Name of Proposed Subdivision HARRIS HEIGHTS ADDITION PHASE THREE

**HARRIS HEIGHTS ADD'N PHASE THREE**  
**S.S. McCURRY SURVEY-ABSTRACT 146**  
**ROCKWALL, ROCKWALL COUNTY**

Re: Harris Heights Addition  
Phase III - ROK 84806

Re: Harris Heights Phases I, II, III,  
and IV - Revised Plat

*1st  
Submission*

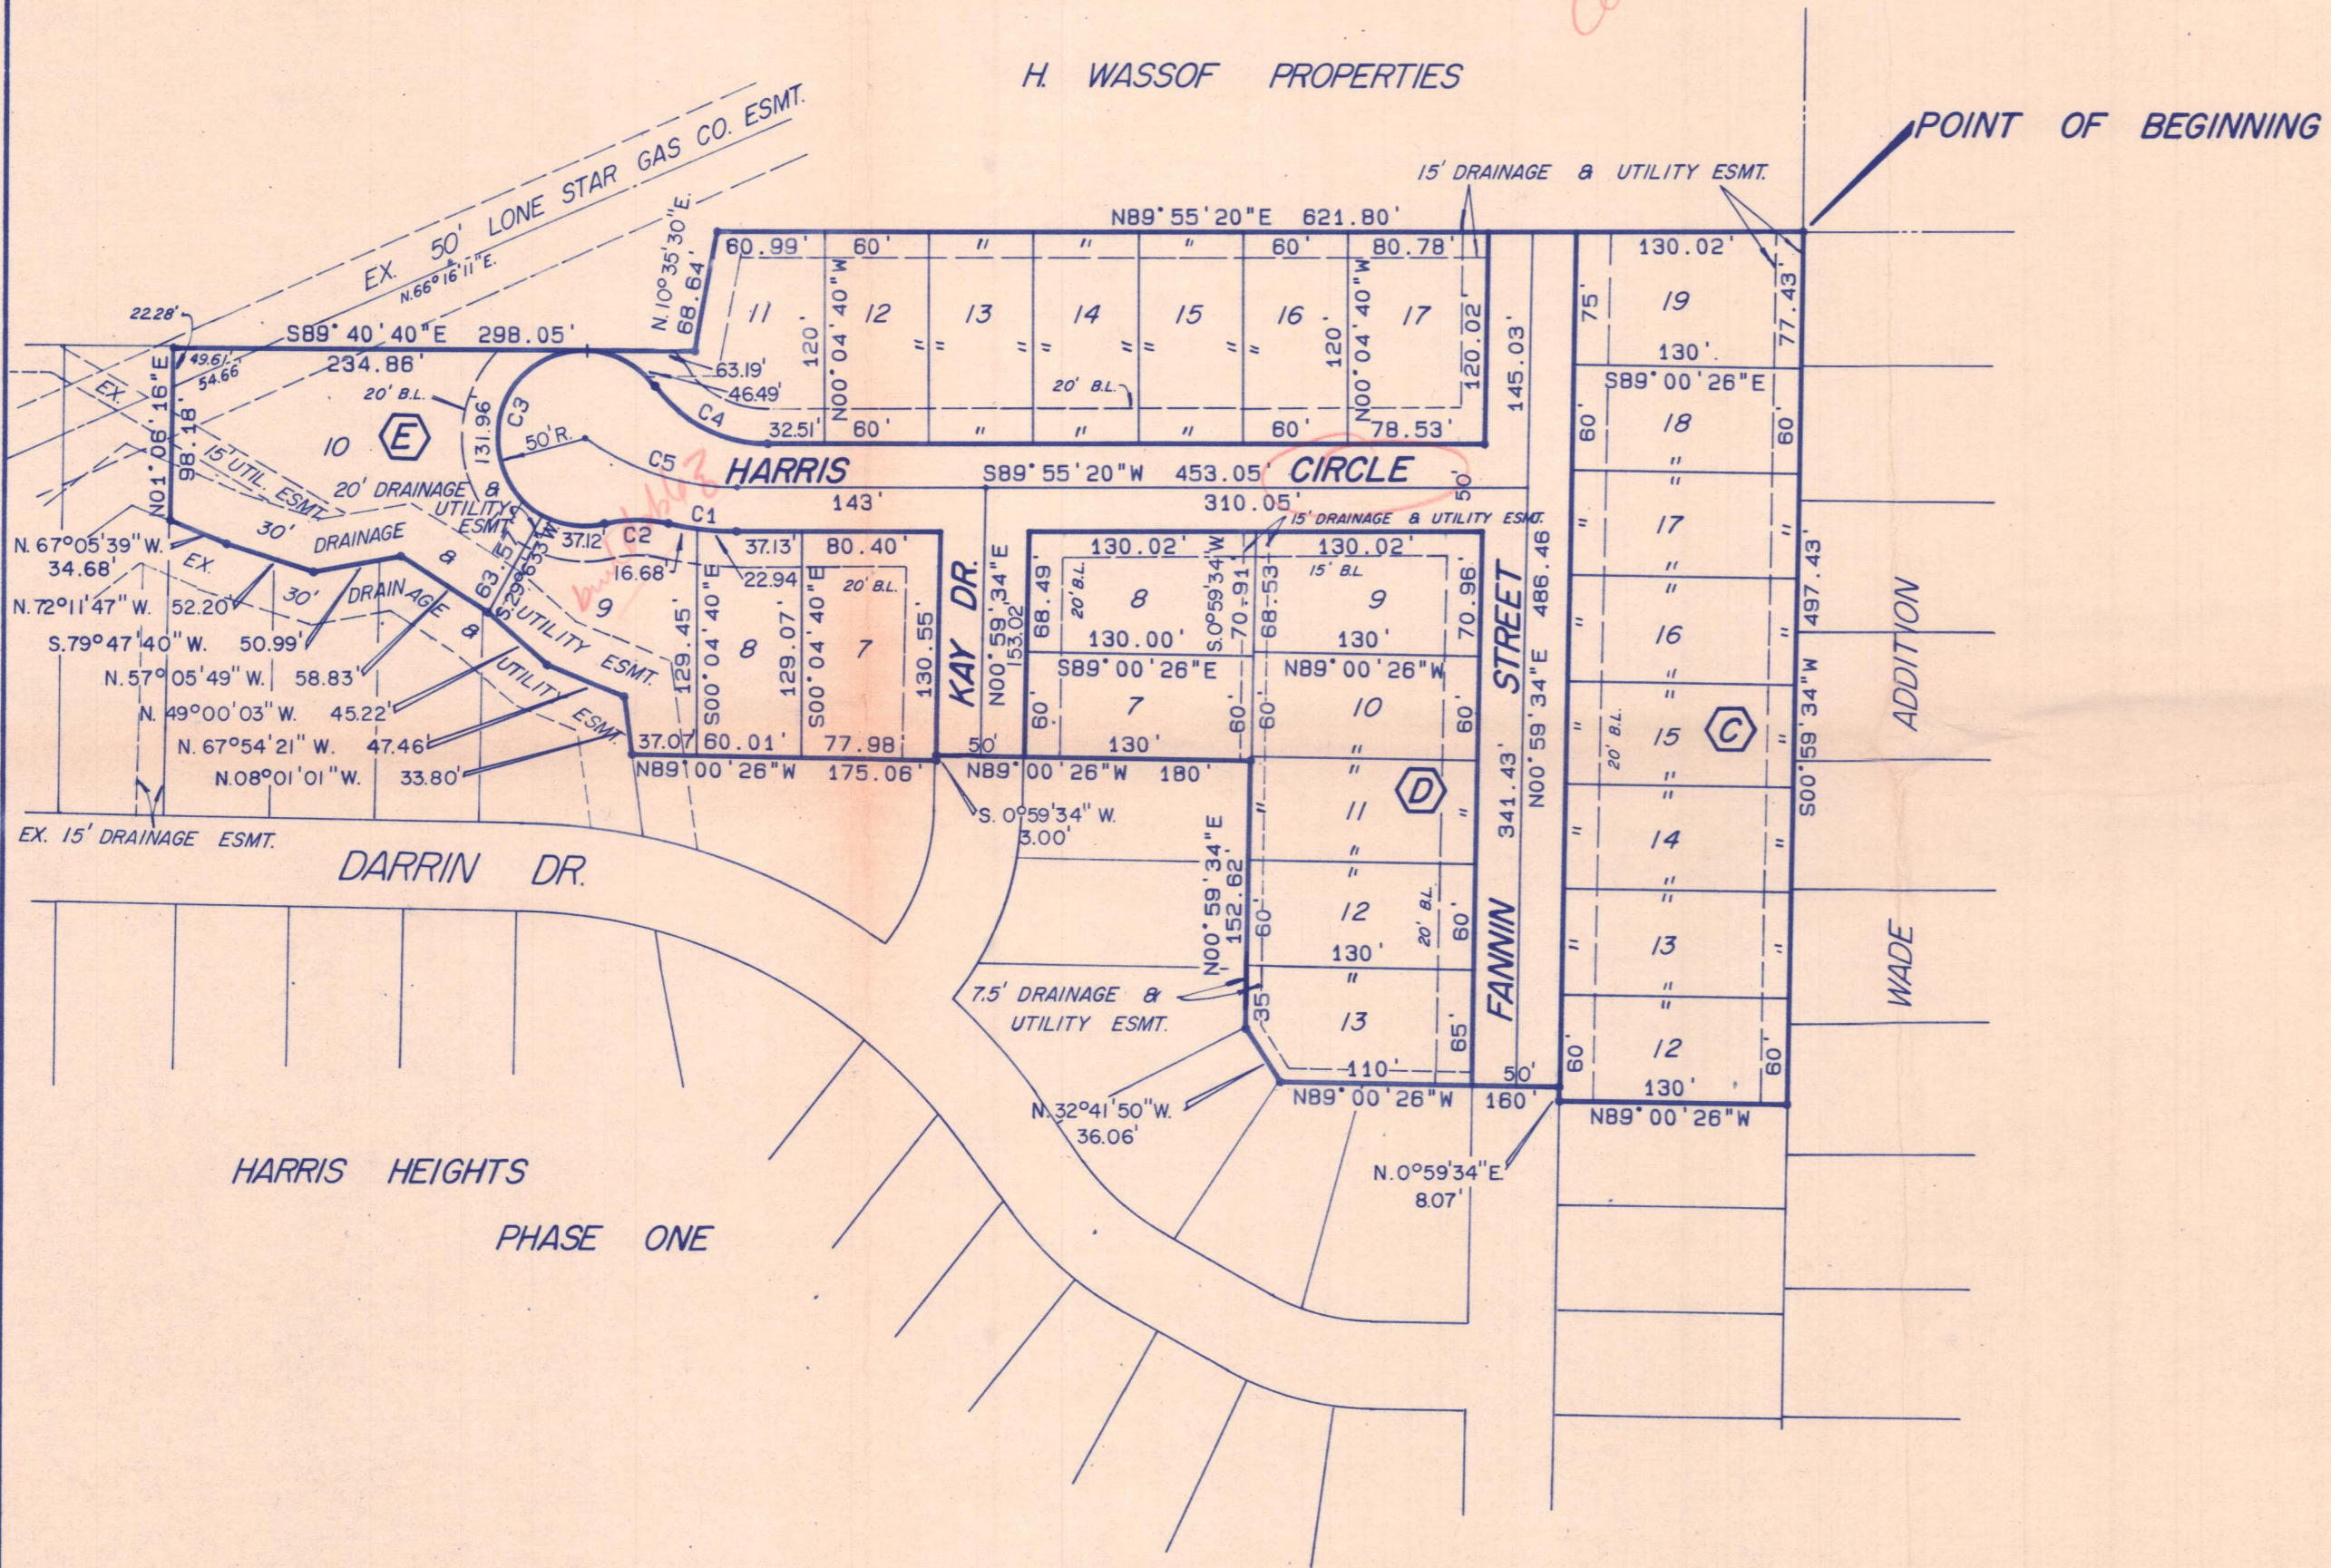
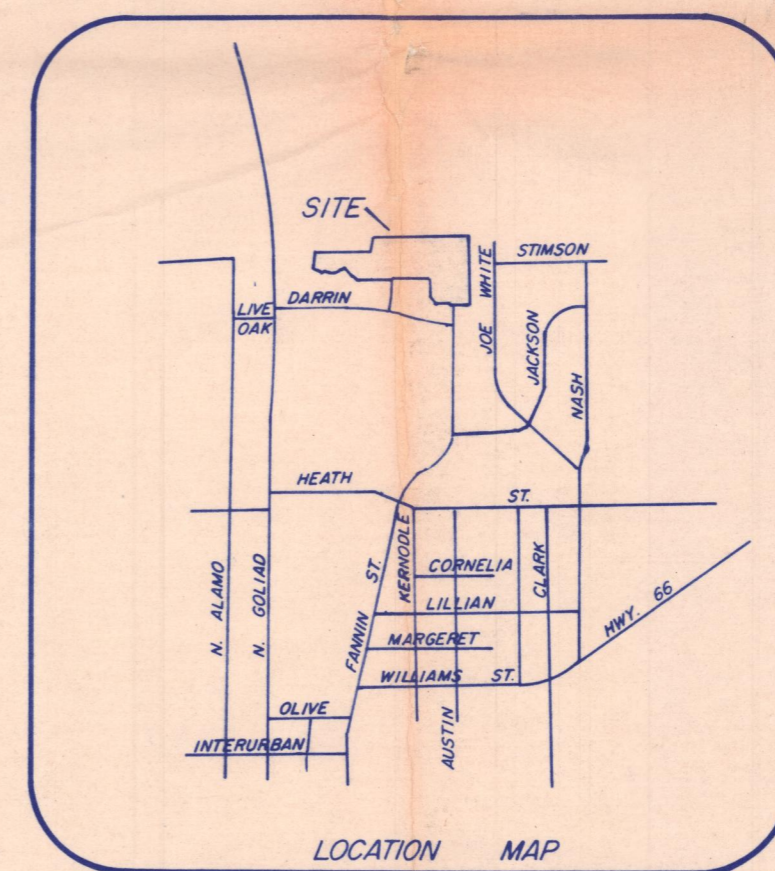
*check drainage  
off C -  
this is where  
neighbors  
complained*

*2nd  
Submission*

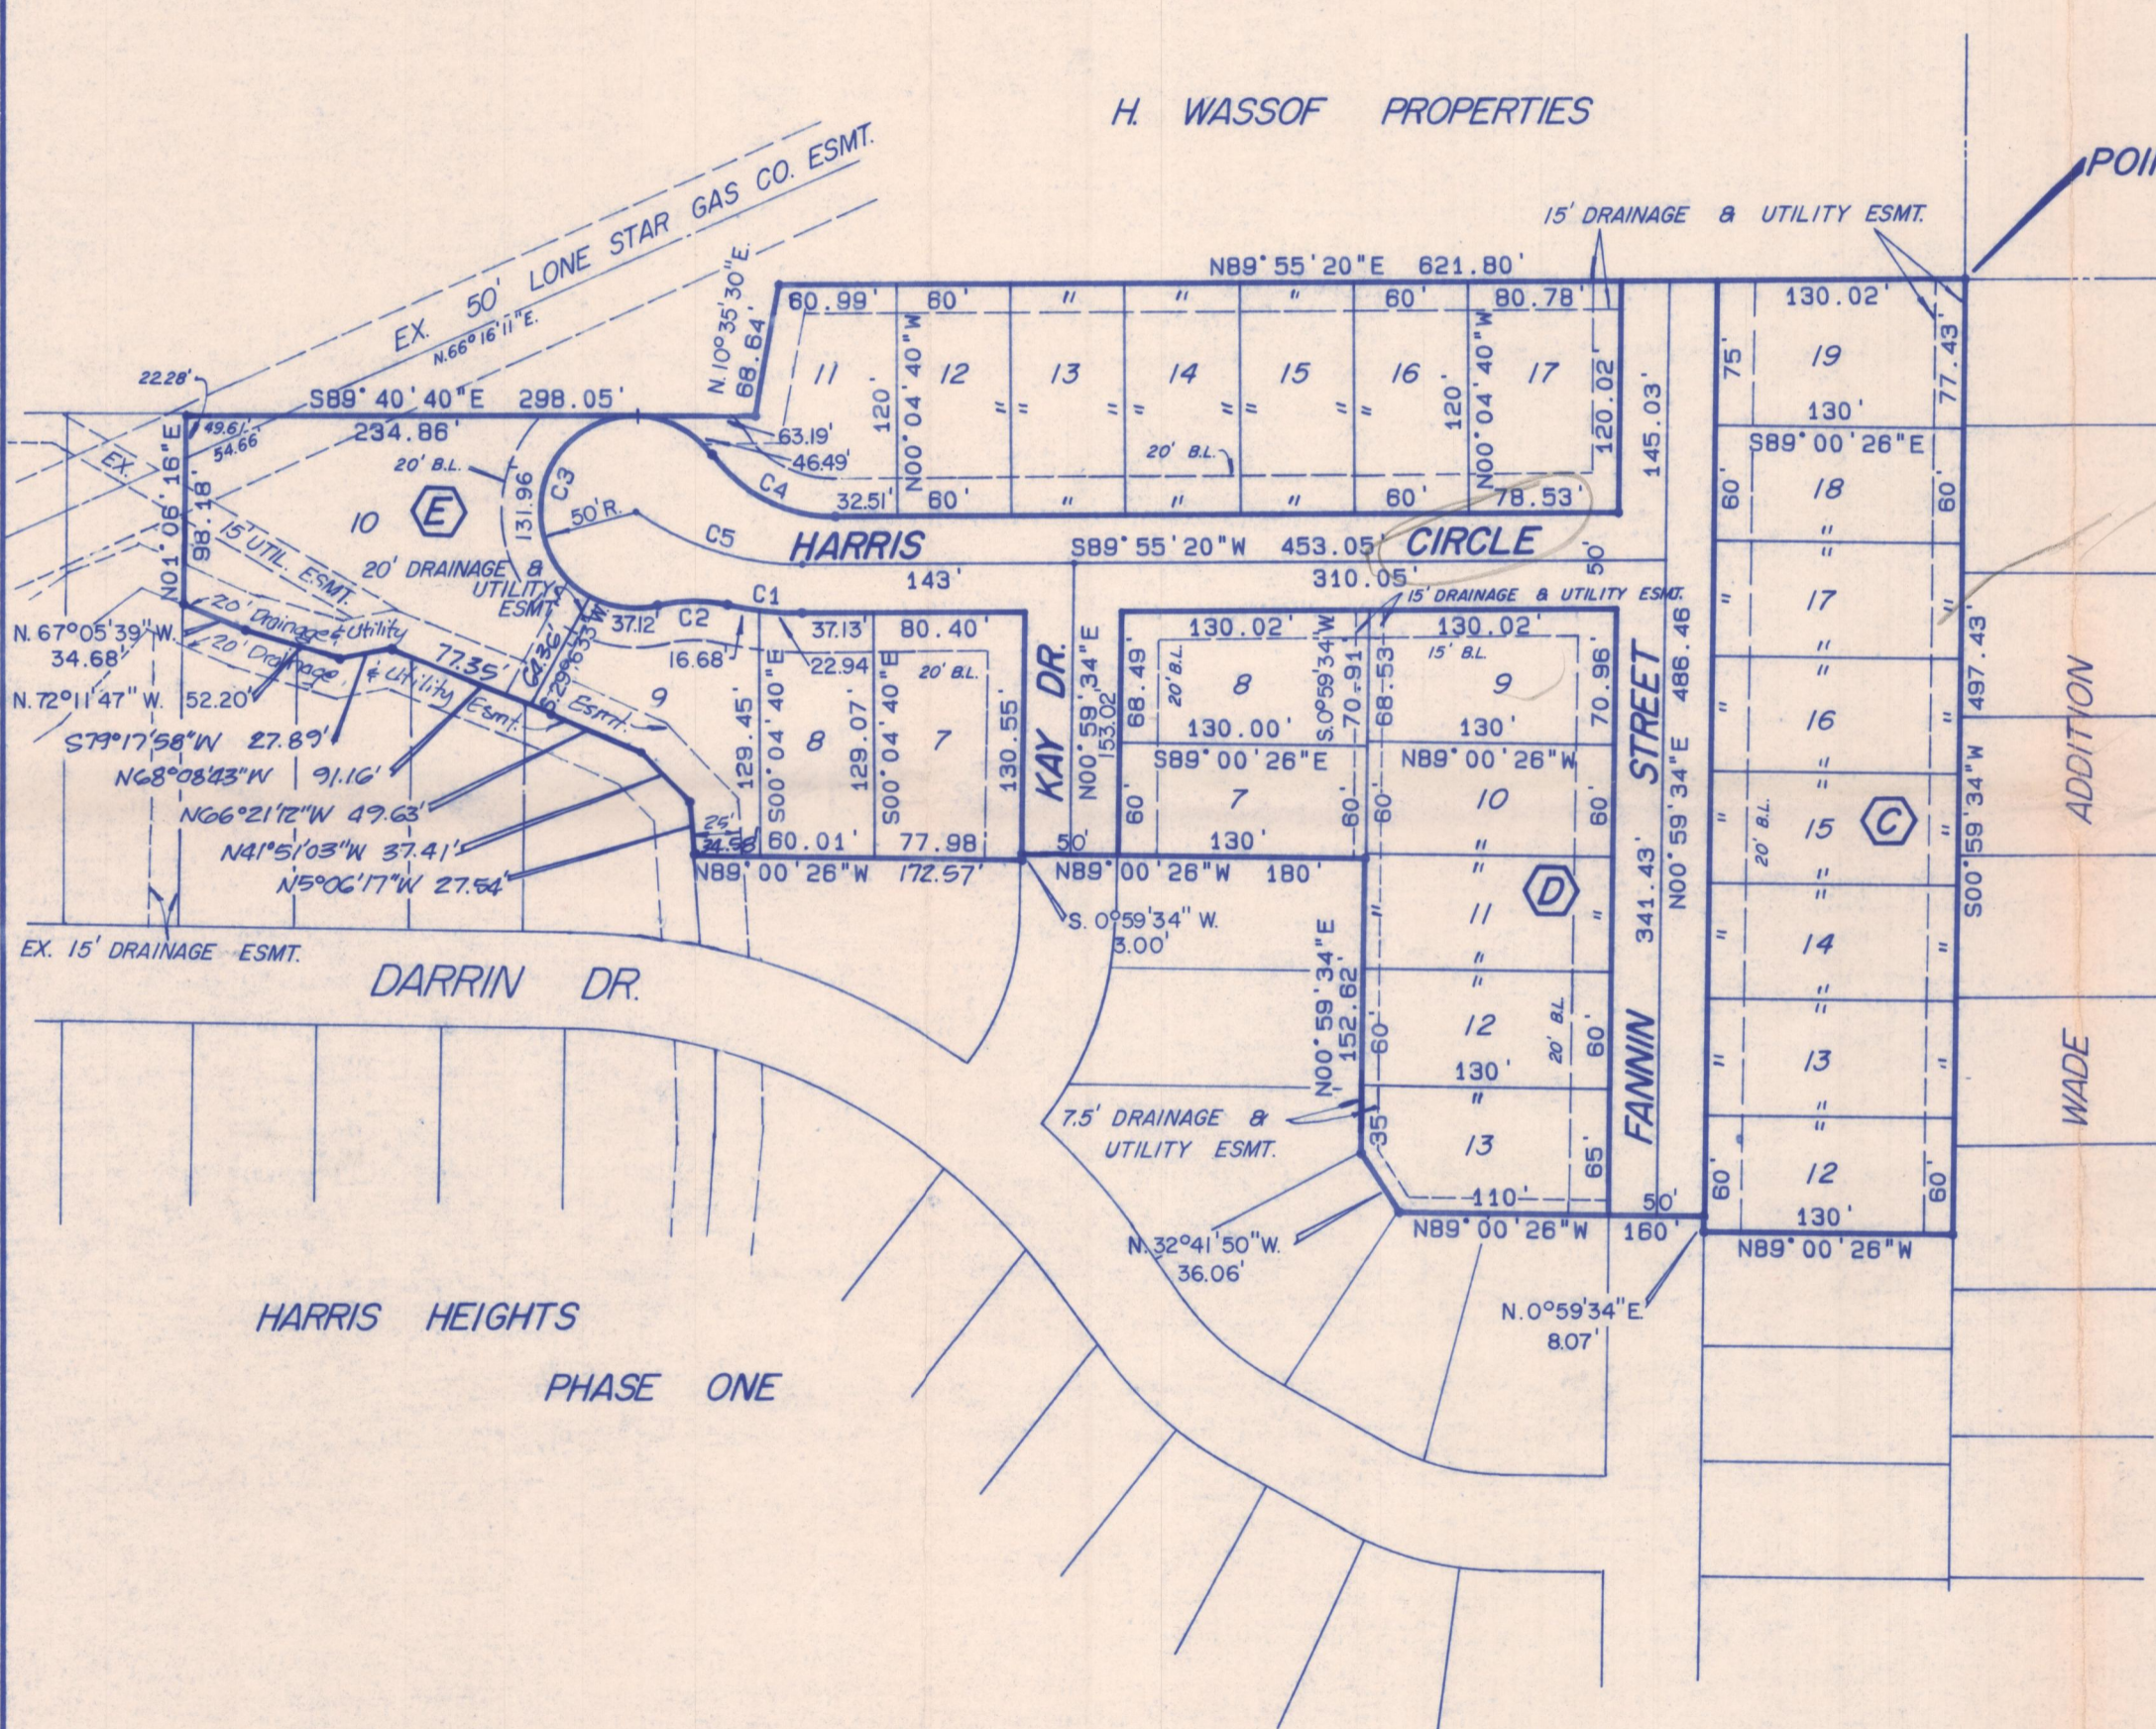
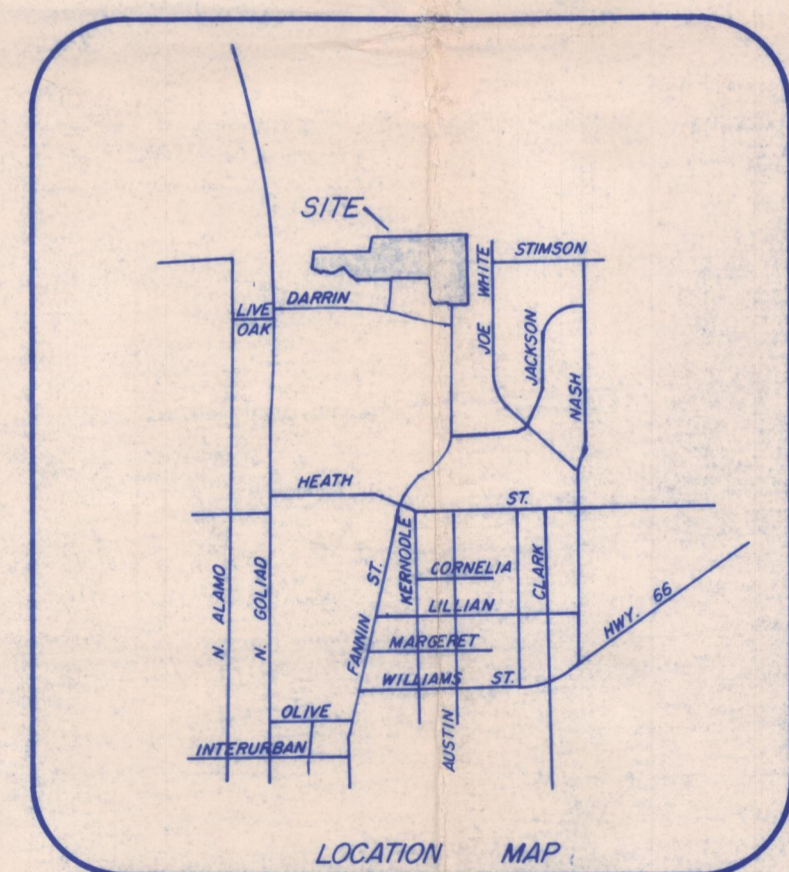
*be sure  
check  
drainage*
